**MASTER PLAN AND ZONING COMMITTEE**  
**City of Novi Planning Commission**  
**November 08, 2017 at 6:00 p.m.**  
**Novi Civic Center – Mayor’s Conference Room**  
**45175 W. Ten Mile, Novi, MI 48375**  
**(248) 347-0475**  
**AGENDA**

**TO:** MASTER PLAN AND ZONING COMMITTEE  
**FROM:** SRI RAVALI KOMARAGIRI, PLANNER  
**THRU:** BARBARA MCBETH, AICP, CITY PLANNER  
**SUBJECT:** CONSIDERATION OF PRO CONCEPT PLAN FOR OBERLIN WEST  
**DATE:** NOVEMBER 06, 2017

# JSP17-49 Oberlin West: Rezoning 18.721

**Review Date:** October 25, 2017  
**Review Type:** PRO Concept Submittal: Initial  
**Project Name:** **JSP 17-49 OBERLIN WEST**  
**Plan Date:** September 15, 2017  
**Prepared by:** Sri Komaragiri, Planner  
**Contact:** **E-mail:** skomaragiri@cityofnovi.org; **Phone:** (248) 735-5607

**Figure 1.** City of Novi Regulated Wetland & Woodland GIS Coverage Map (approximate project boundary shown in red). Regulated Woodland areas are shown in green and regulated Wetland areas are shown in blue.

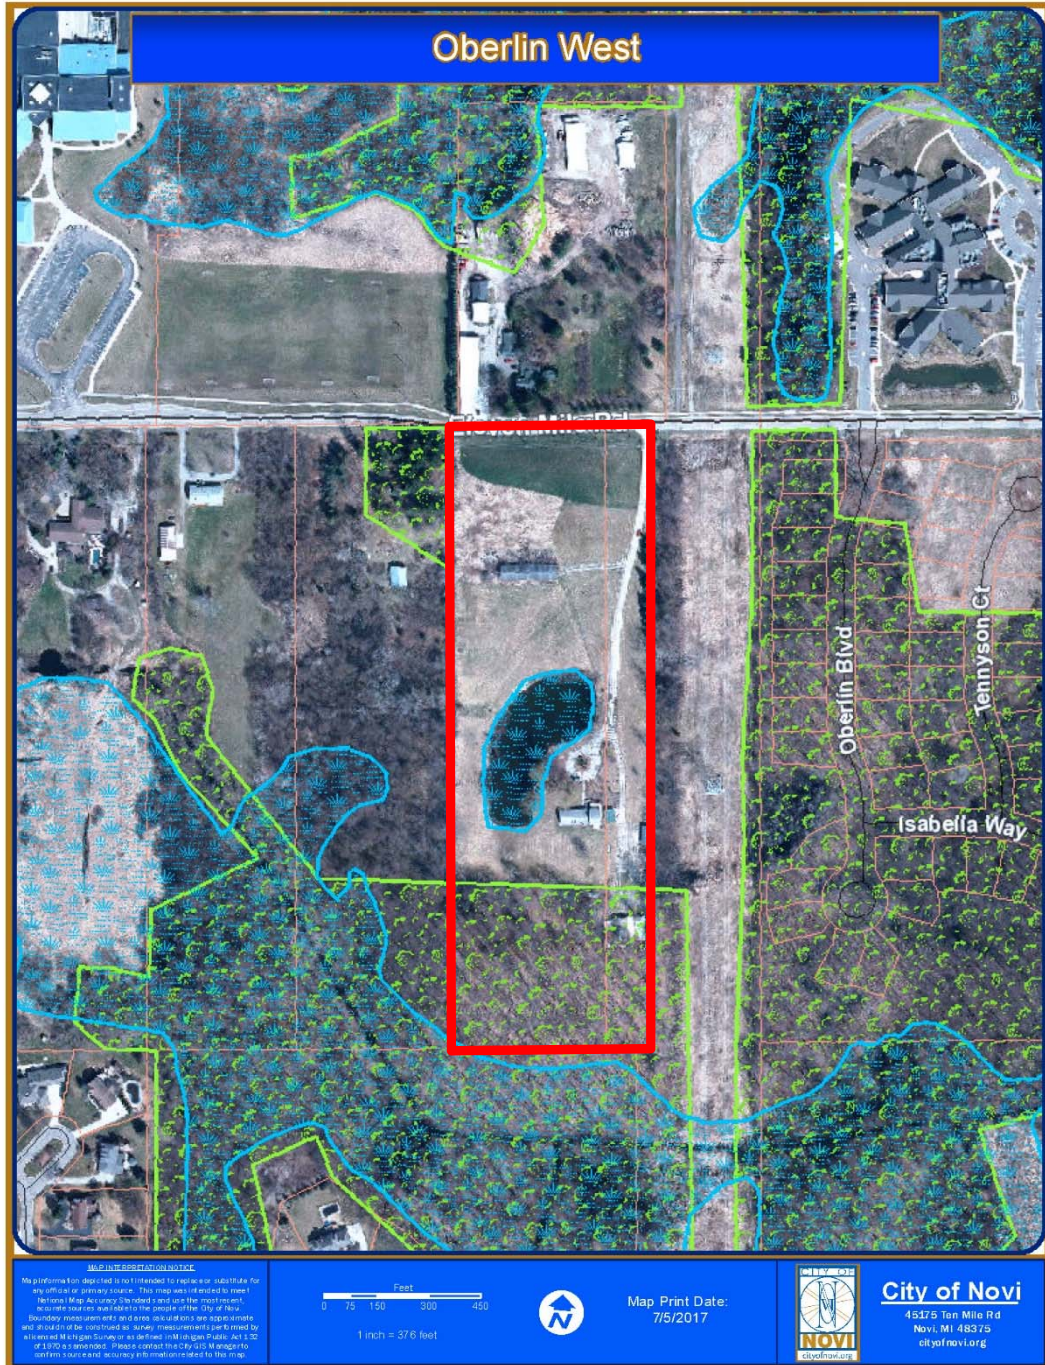
Based on our review of the Plan, Novi aerial photos, Novi GIS, and the City of Novi Official Wetlands and Woodlands Maps (see Figure 1), it appears as if this proposed project site contains Regulated Wetlands as well as Regulated Woodlands. The majority of the subject site appears to have been previously disturbed (see Figure 2, 1963 aerial photo). The open water/emergent wetland area located in the central portion of the proposed development has been present in some fashion since at least 1940 (see Figure 3, 1940 aerial photo). It is ECT's opinion that this wetland area was not originally constructed solely for stormwater storage, but has historically been a wetland area. This wetland area is indicated as regulated on the City of Novi Official Wetland and Woodlands Map. The southern section of the site contains an area mapped as City of Novi Regulated Woodlands. The site contains an existing residence and several other existing buildings/structures.

**Figure 1.** City of Novi Regulated Wetland & Woodland GIS Coverage Map (approximate project boundary shown in red). Regulated Woodland areas are shown in green and regulated Wetland areas are shown in blue.

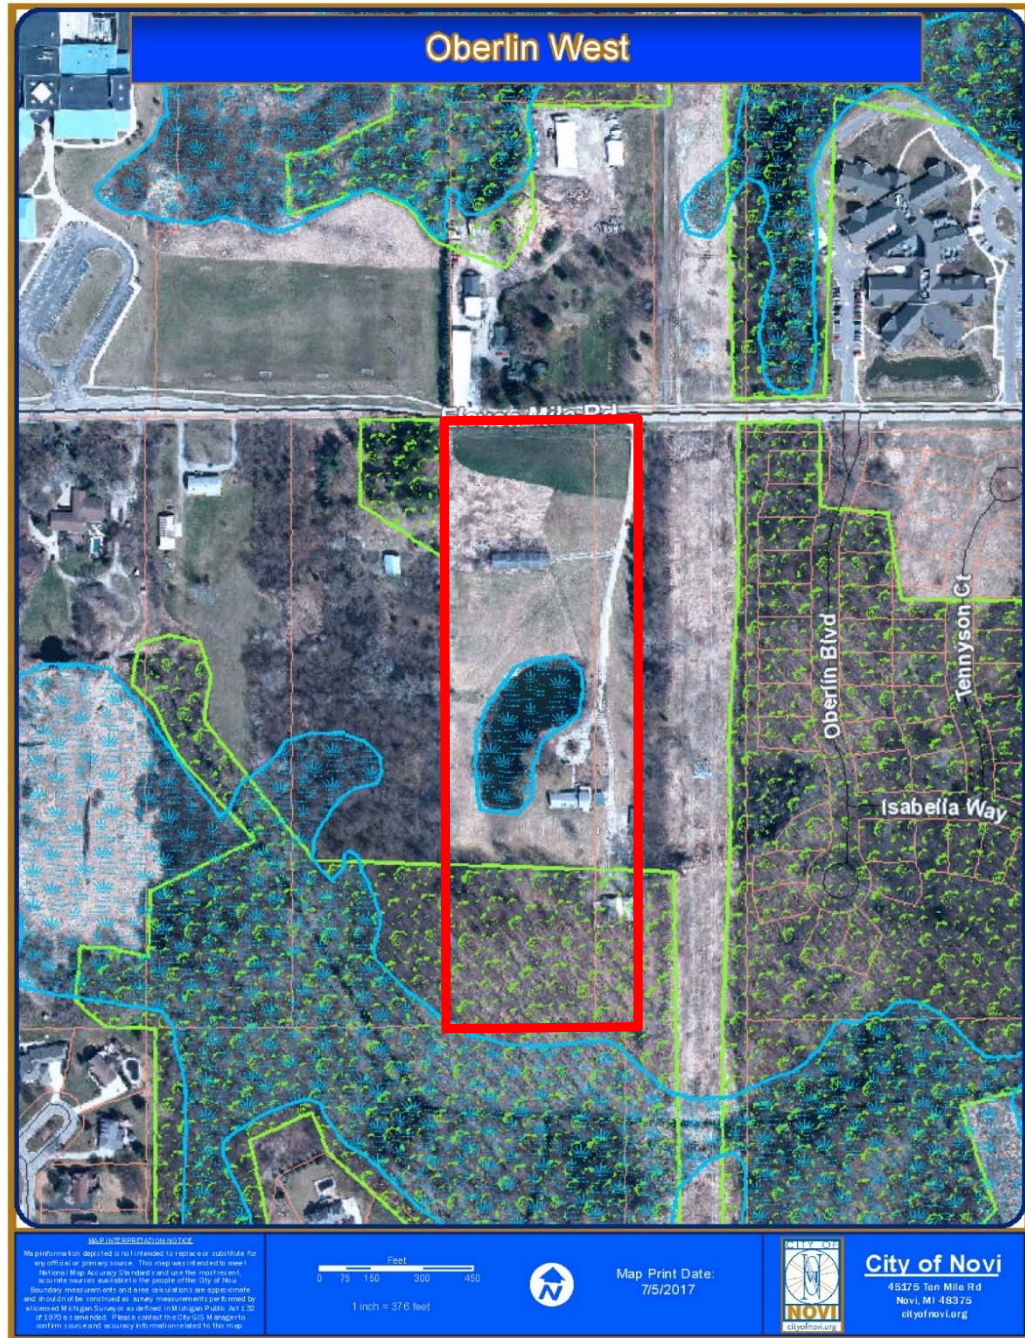
The majority of the City Regulated Woodland area is located on the southern (1/4) portion of the project site (see Figure 1). The *Existing Conditions and Demo Plan* (Sheet 02) notes that the existing on-site trees are predominantly sugar maple (*Acer saccharum*) and black cherry (*Prunus serotina*) with scattered American beech (*Fagus grandifloras*), basswood (*Tulia americana*), and bitternut hickory (*Cary cordiformis*). A tree row is present along the eastern boundary of the subject site. This tree row consists of silver maple (*Acer saccharin*), mulberry (*Mores spp.*), black cherry, and box elder (*Acer negundo*).
